Addendum No.3
to
CONSTRUCTION DOCUMENTS
for

NCISD New District Administration Building
21330 Valley Ranch Parkway
New Caney, TX. 77357
June 2, 2025

Below is a summary of the sheet and specification revisions for Addendum #3.

C7.01

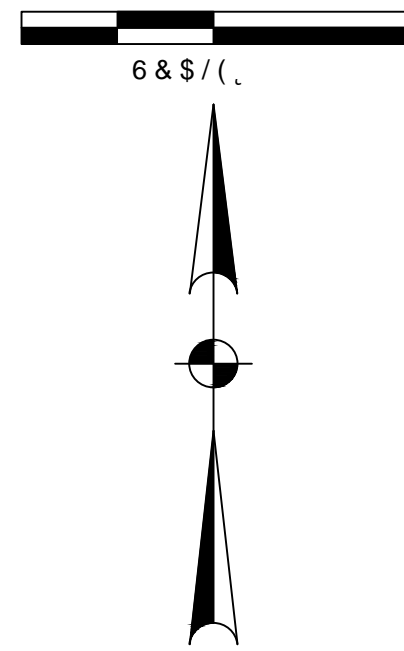
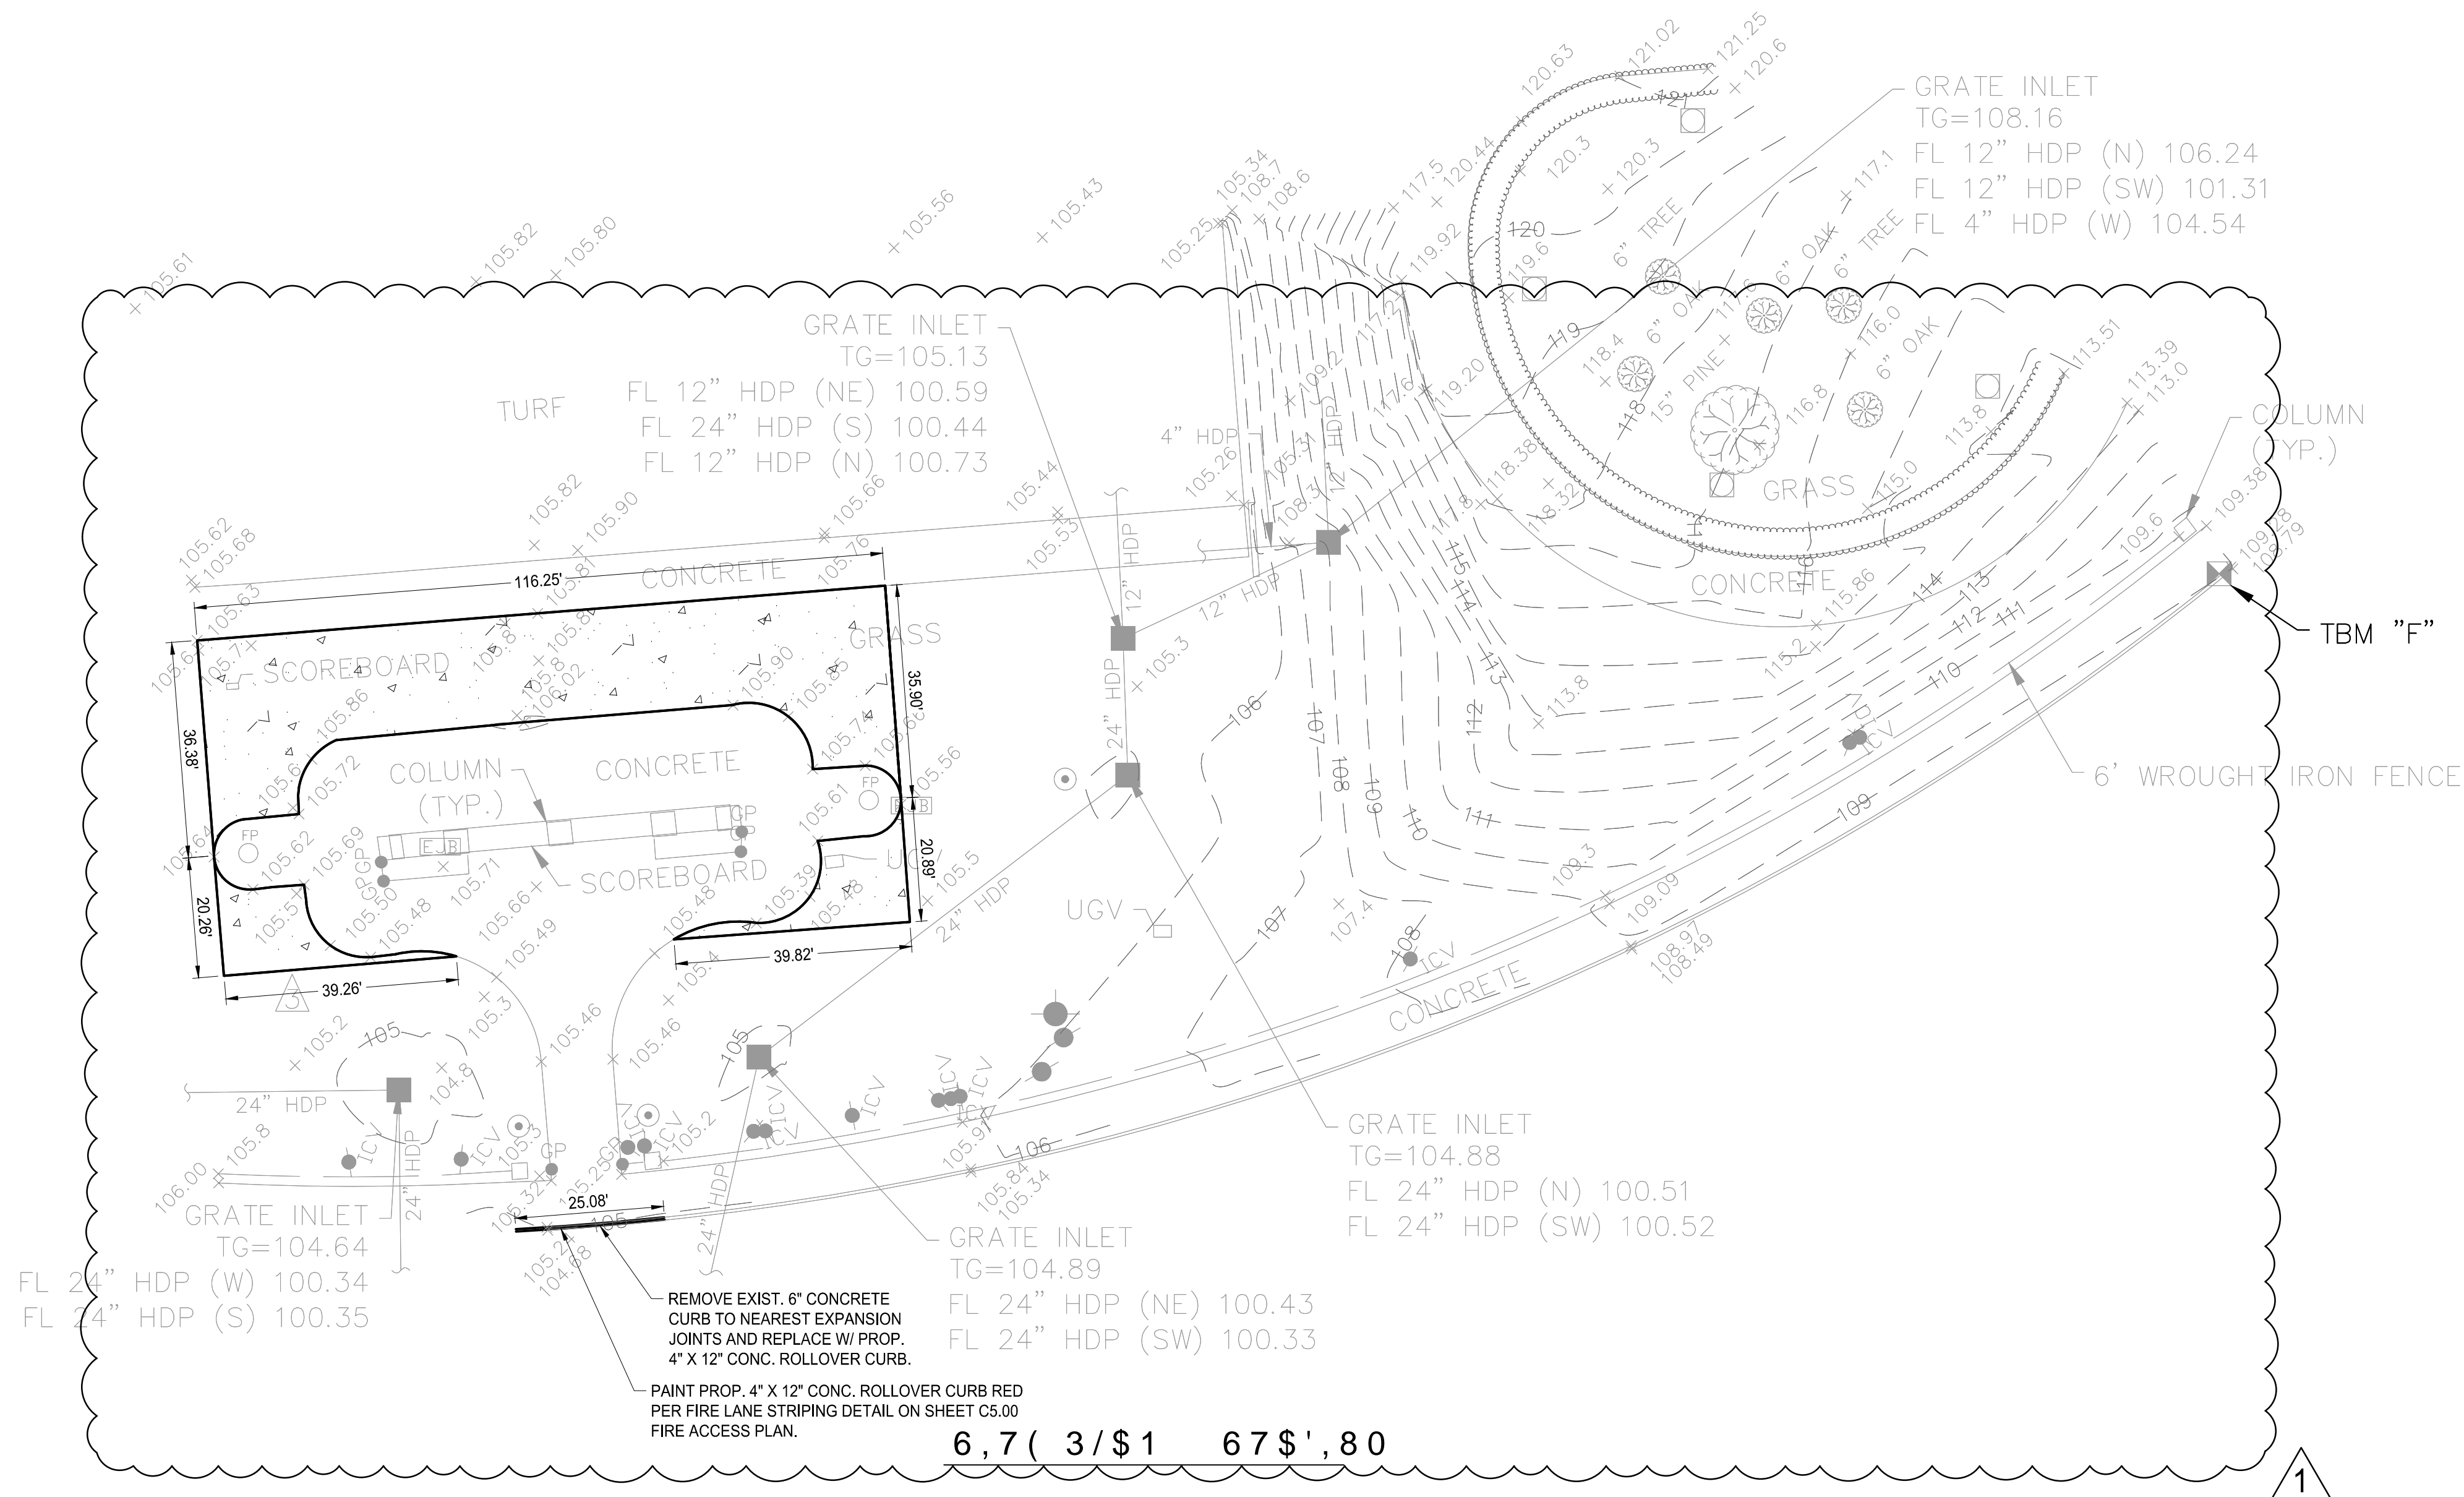
C7.01 DETENTION POND PLAN

- Added detail for earthen emergency overflow spillway.
- Revised emergency overflow spillway material from concrete to earthen.

C14.00

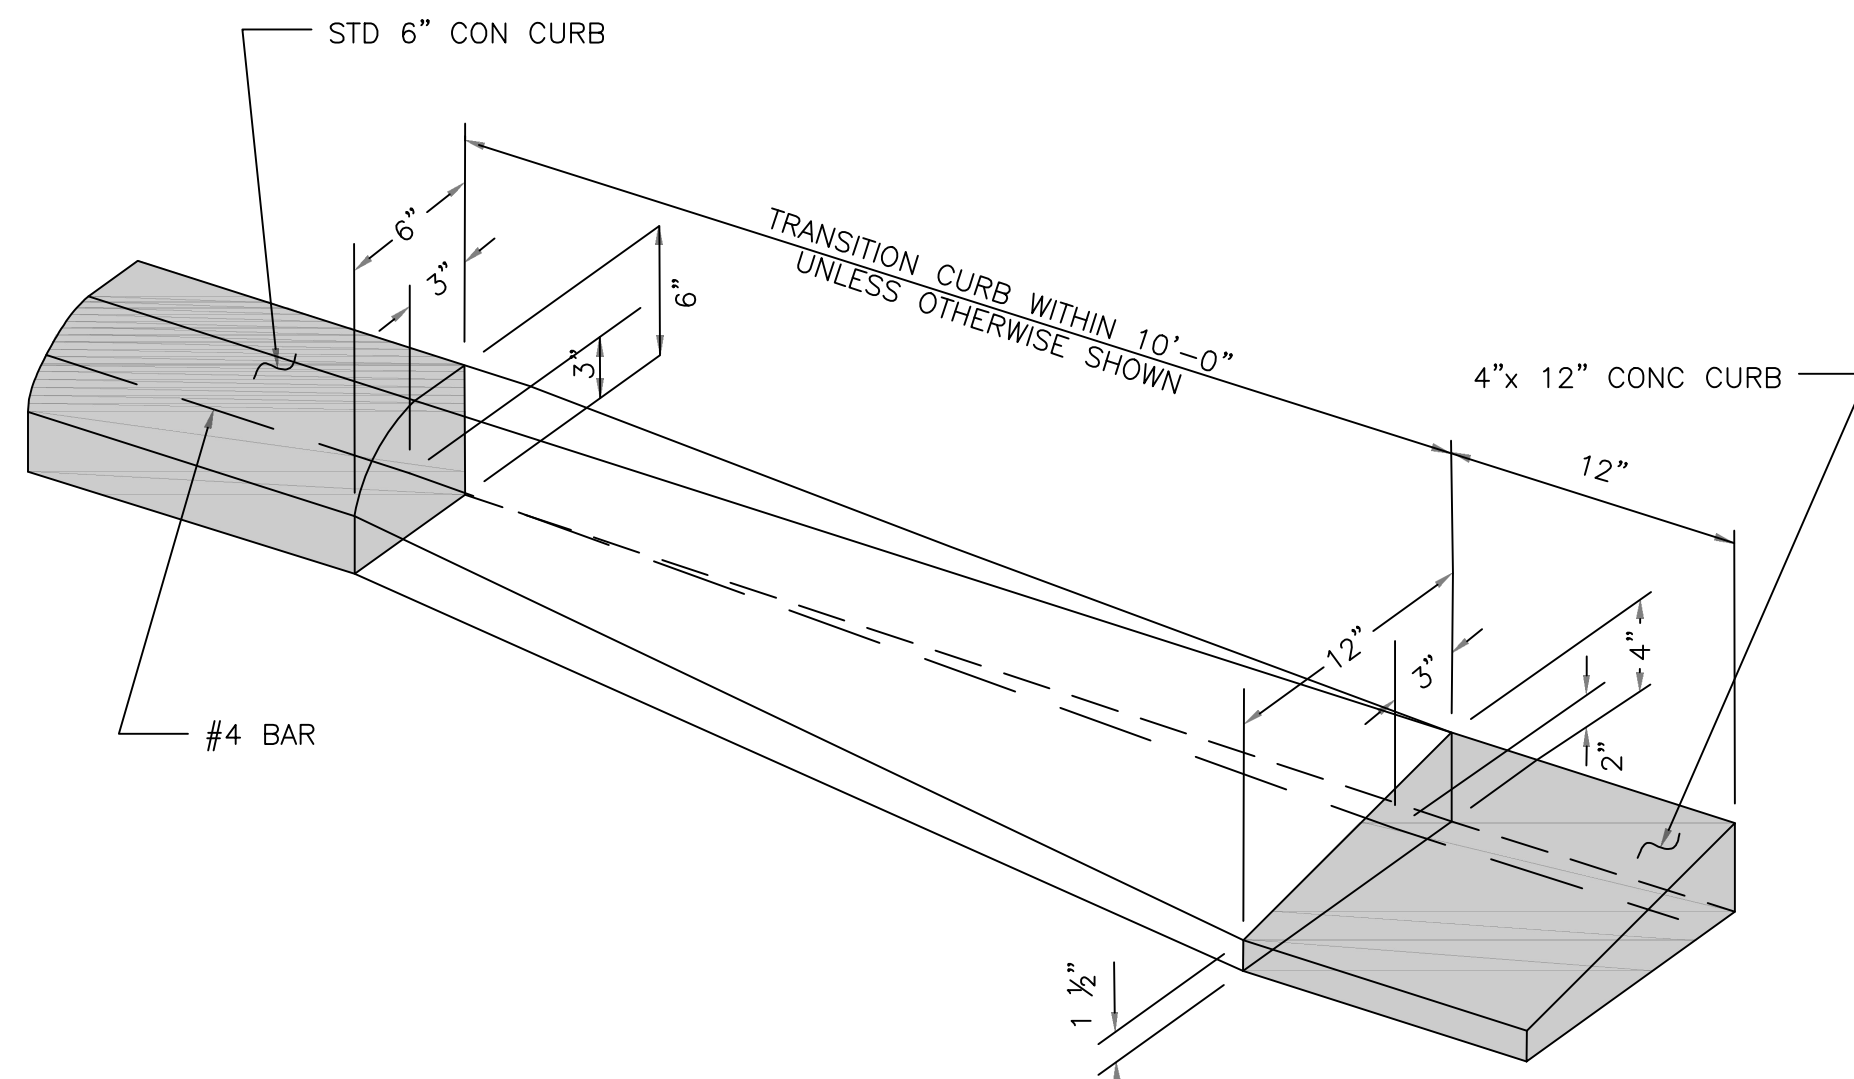
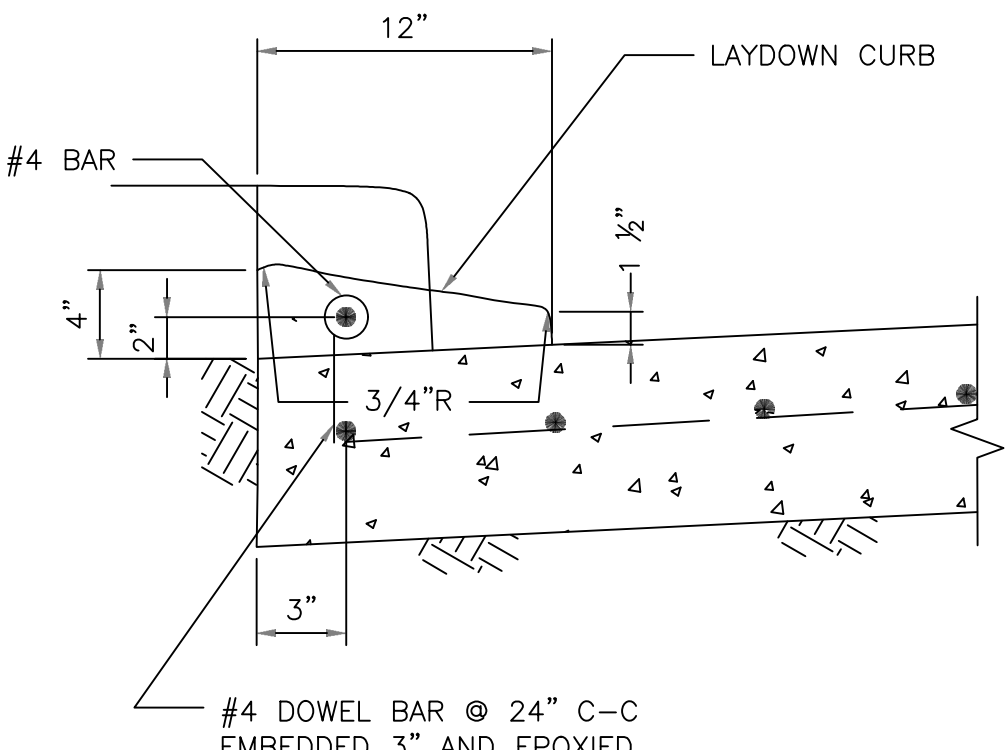
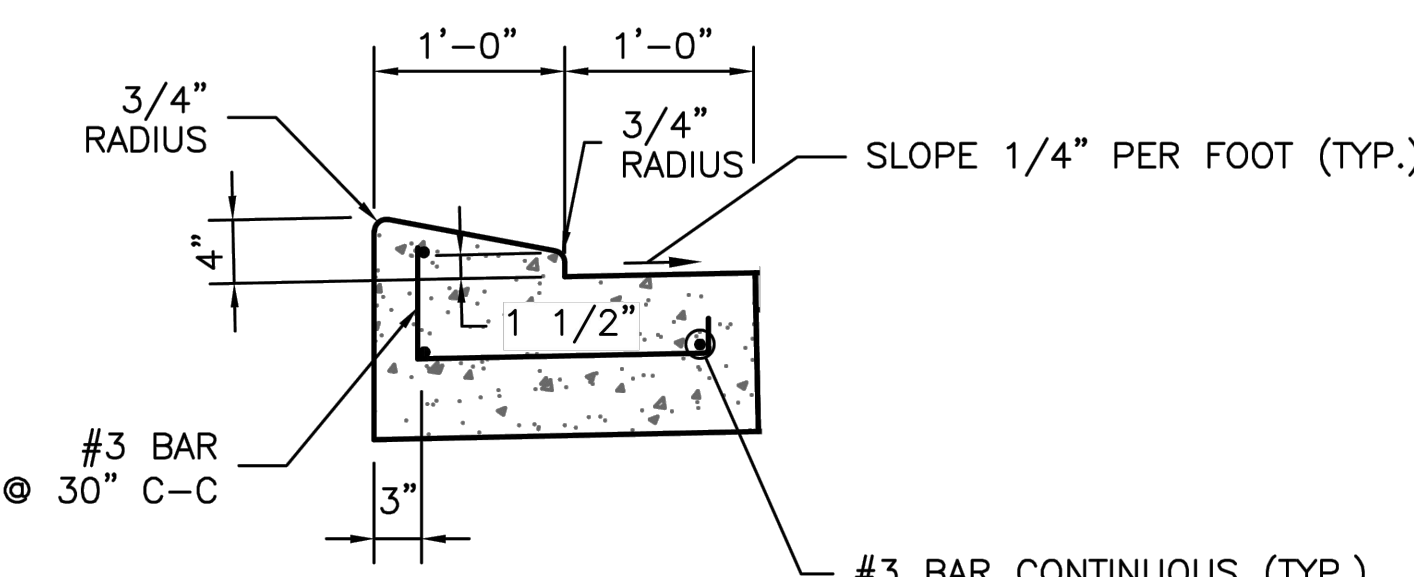
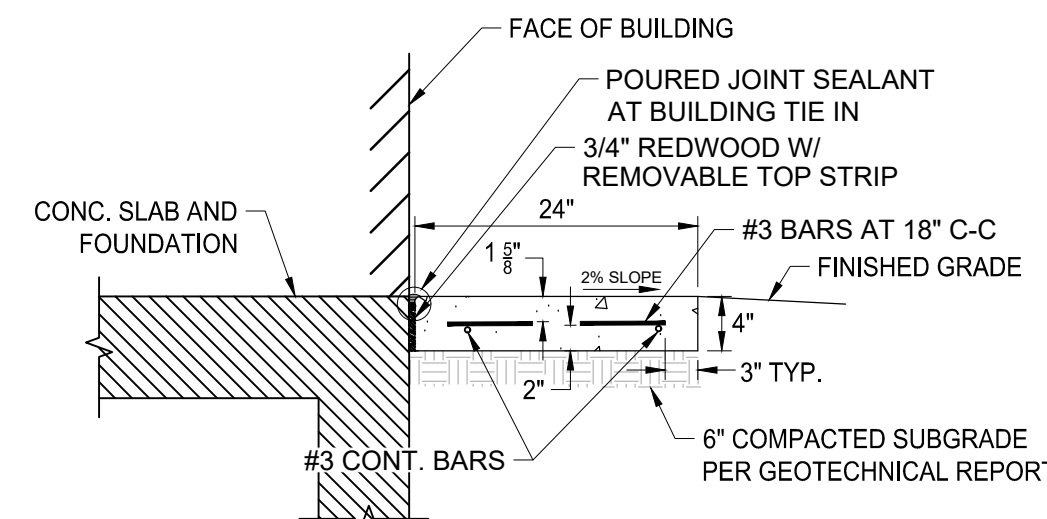
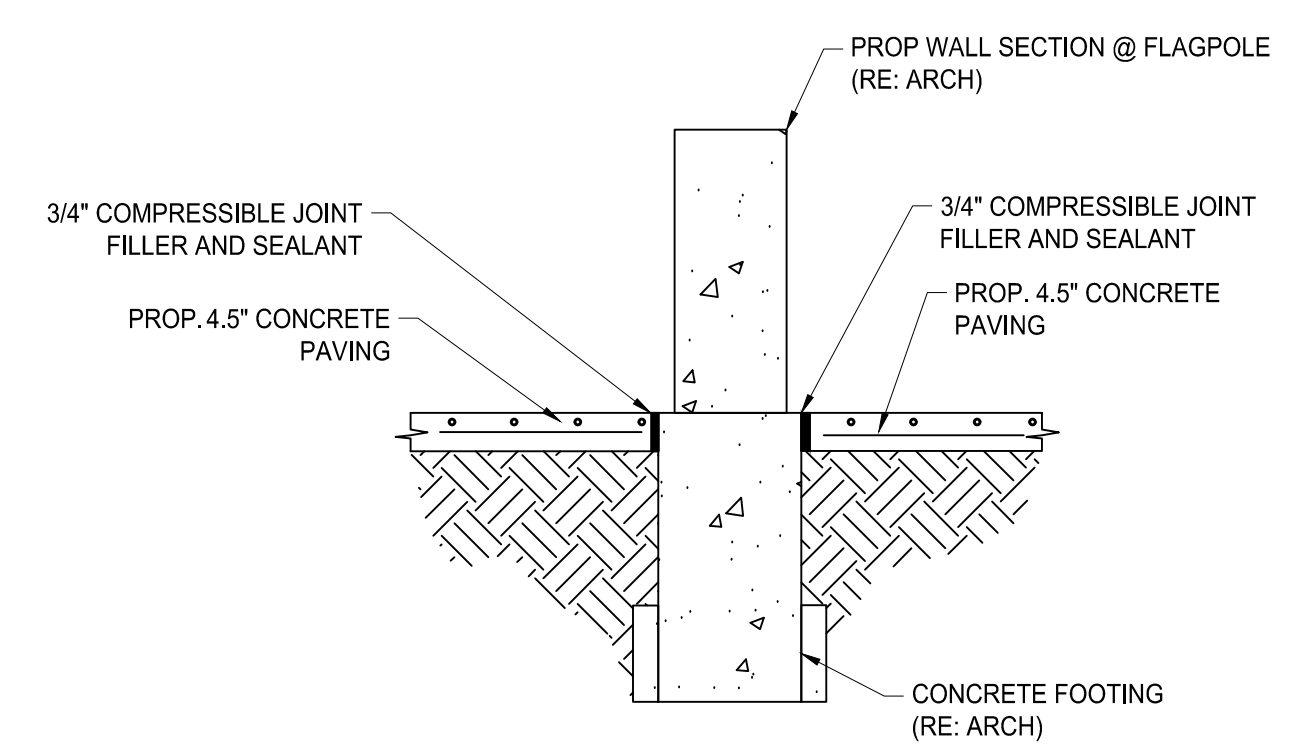
- Added detail for 4"x12" rollover curb.
- Added detail for transition from 6" curb to 4"x12" rollover curb.
- Added detail for sidewalk adjacent to flagpole base.
